MAG 208 Water Quality Management Plan
Small Plant Review and Approval
for

The Preserve at Goldfield Ranch Water Reclamation Facility

April 9, 2008

Hydrogeologic Cross-Section

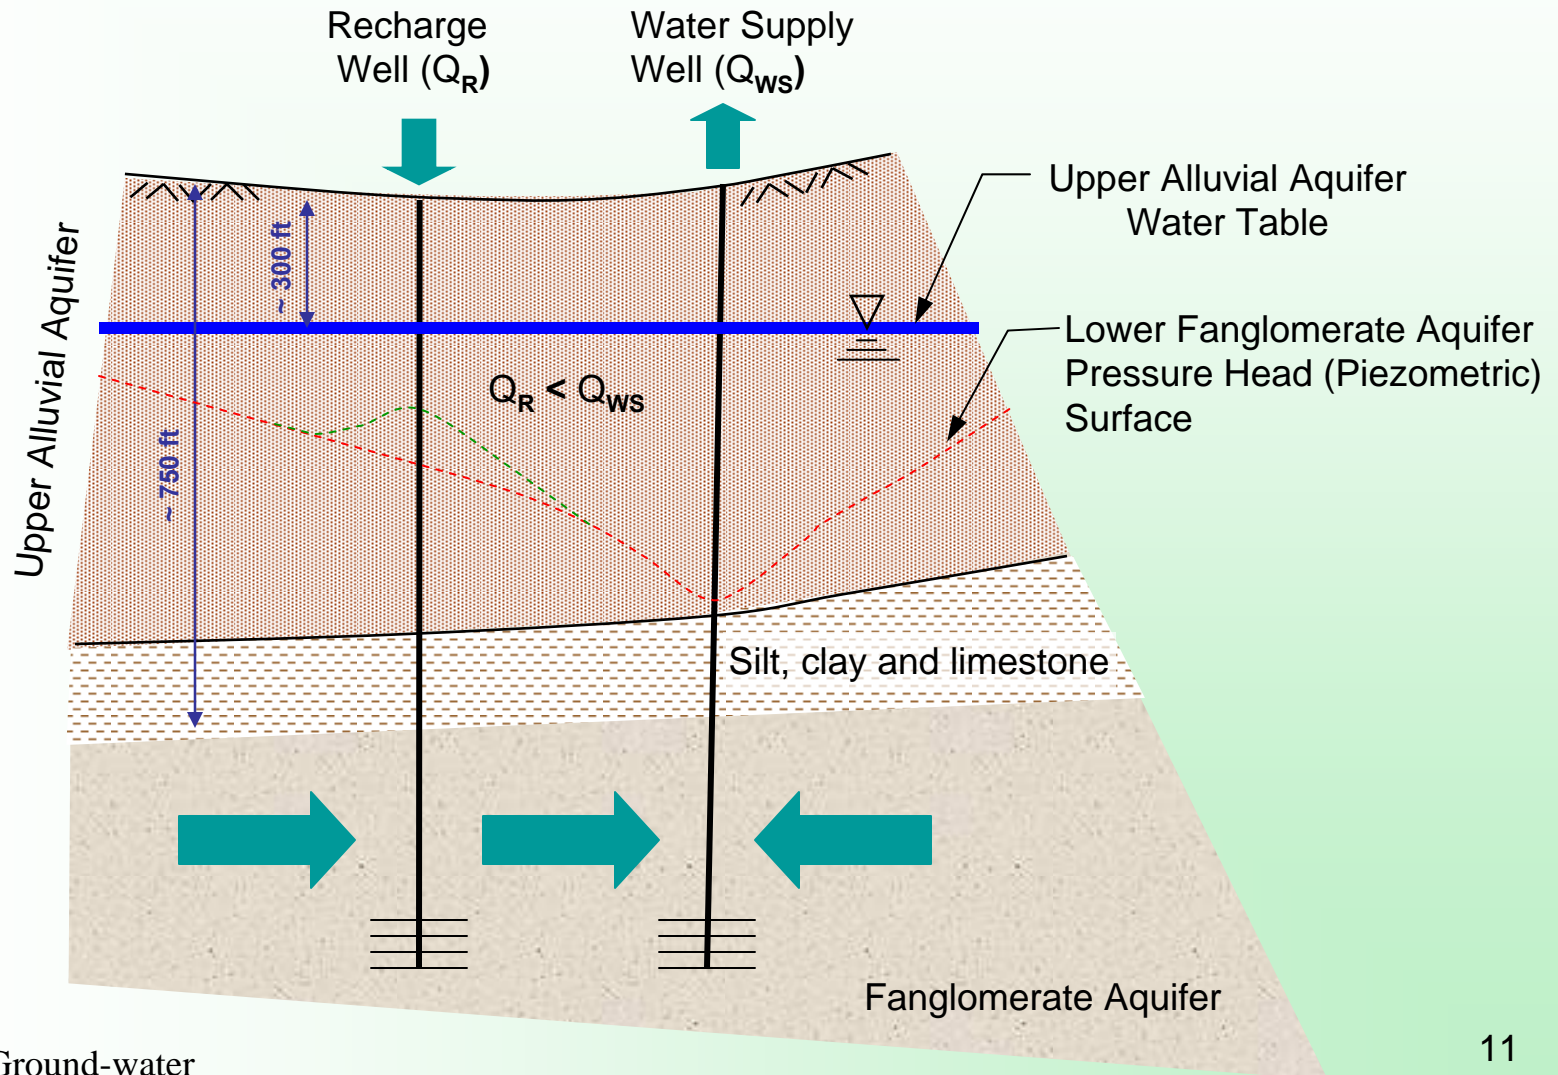
- Comment: Clay layer does not confine the upper and lower aquifer and thins out at the edges
- Response:
 - Water quality concerns addressed irrespective

- Well tests performed on site show aquifer is confined
 - Additional investigation is ongoing
 - Reference materials supporting presence of confining clay layer (playa deposit)

WRF Conceptual Site Plan

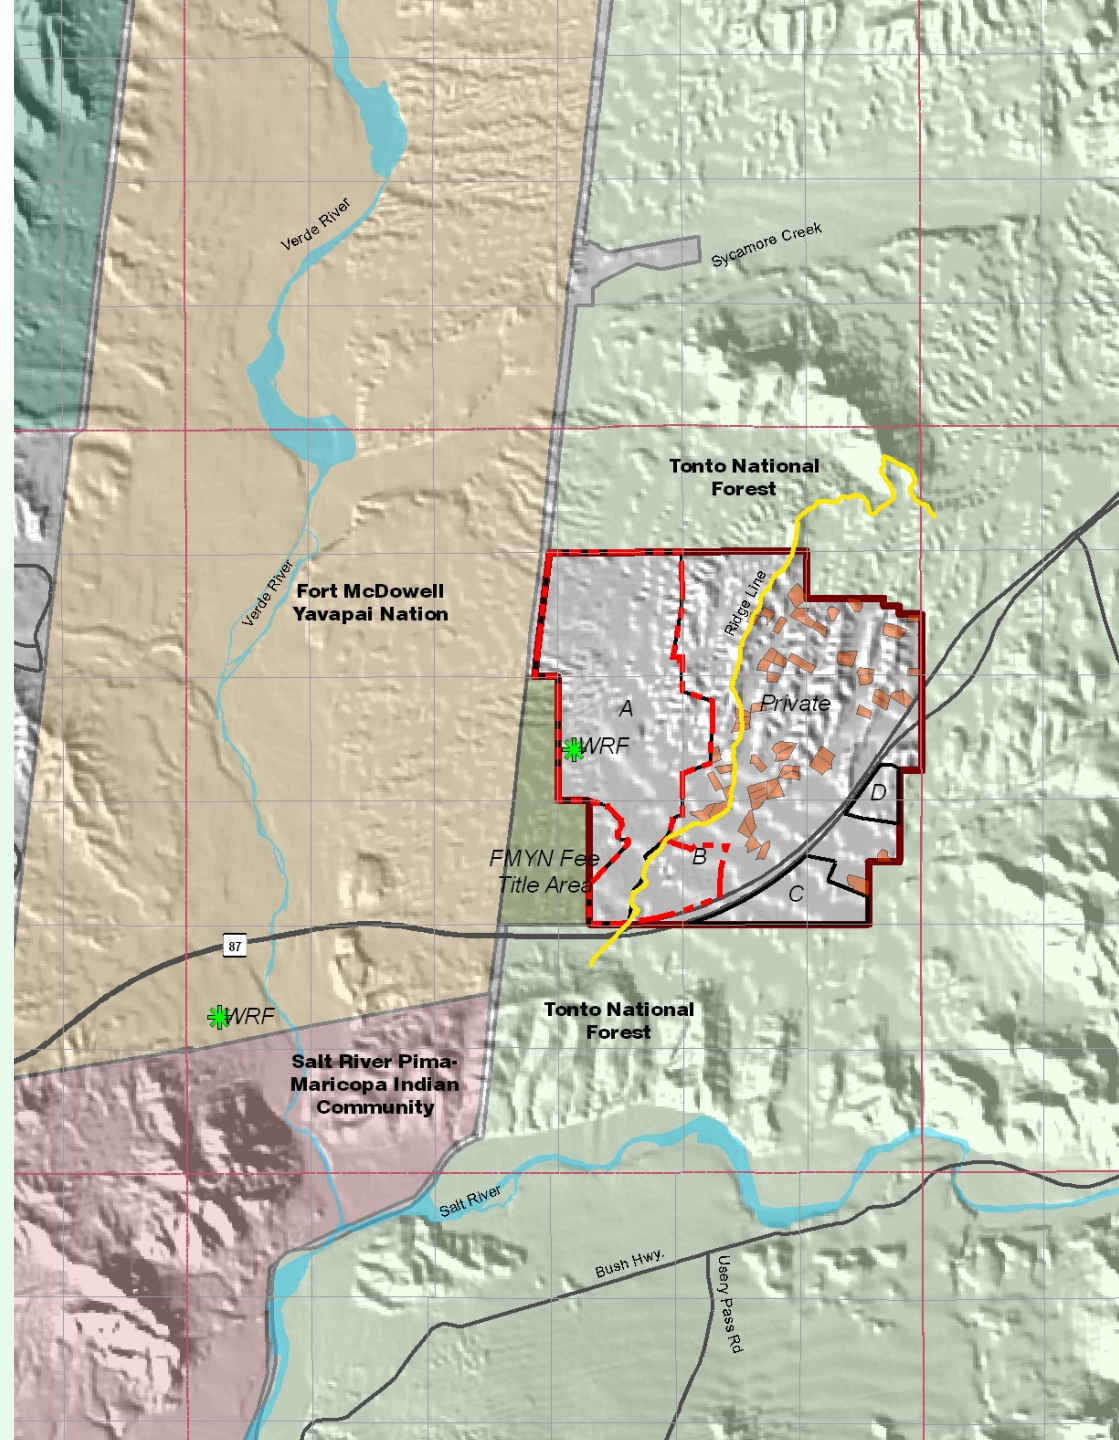
- Comment: Commit to specific treatment plan to identify noise, odor potential
- Response:
 - Conceptual site plan shows 100' setbacks
 - Nearest adjacent neighbors are within The Preserve development
 - Full noise, odor and aesthetic controls means:
 - Noise does not exceed 50 decibels at property boundary
 - Normal conversation = 60 decibels
 - All odor-producing components of the facility are fully enclosed (CLOSED SYSTEM)
 - Odor control devices are installed on all vents
 - Fencing aesthetically matched to surrounding area (AAC R18-9-B201)
